# TESSENDERLO KERLEY

Bob Boston  
UTC Rail Safety  
P.O. Box 47250  
Olympia, WA 98504 - 7250  
Subject: Clearance Waiver Request

August 21, 2009

Below is a copy of the drawing with the BNSF approval and comments, I will also attach this document for easier review. Our BNSF contact for this project is Rusty Olsen, Project Engineer, Seattle, WA (206) 625-6189.

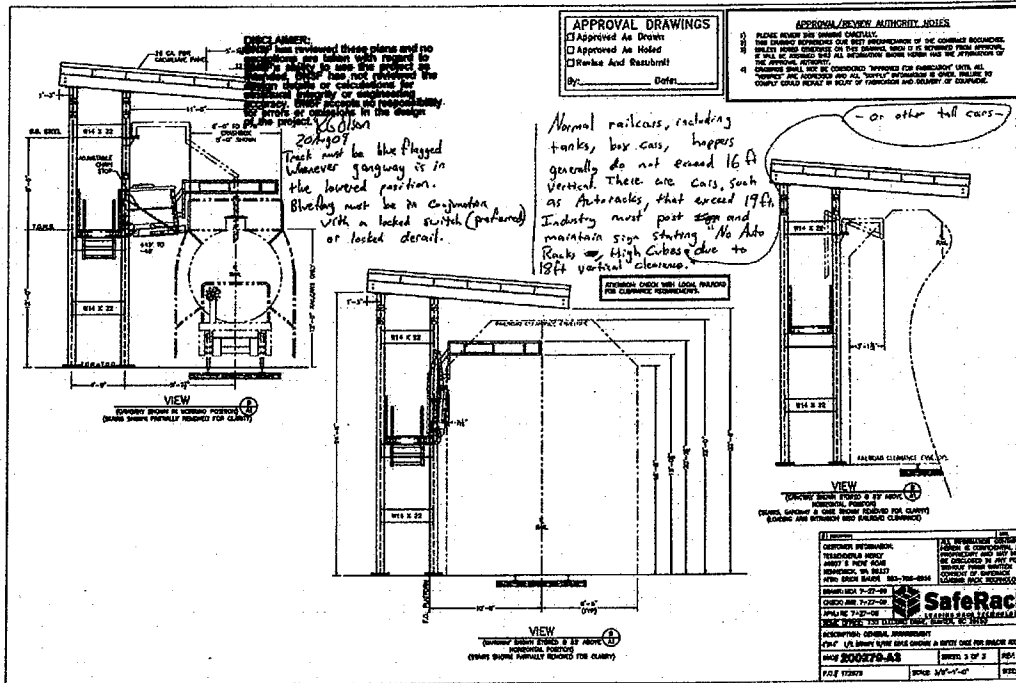
BNSF has reviewed the drawings and has approved our project. They stipulated that the track must be “blue flagged” whenever the gangway is in the lowered position and it must be used in conjunction with a locked switch or derail. They also commented that normal railcars, including tanks, box cars and hoppers generally do not exceed 16 feet vertical height, but there are cars, such as autoracks, that do exceed 19 feet. We will be required to post and maintain a sign stating – “No auto racks, high cubes or other tall cars due to 18’ vertical clearance”.
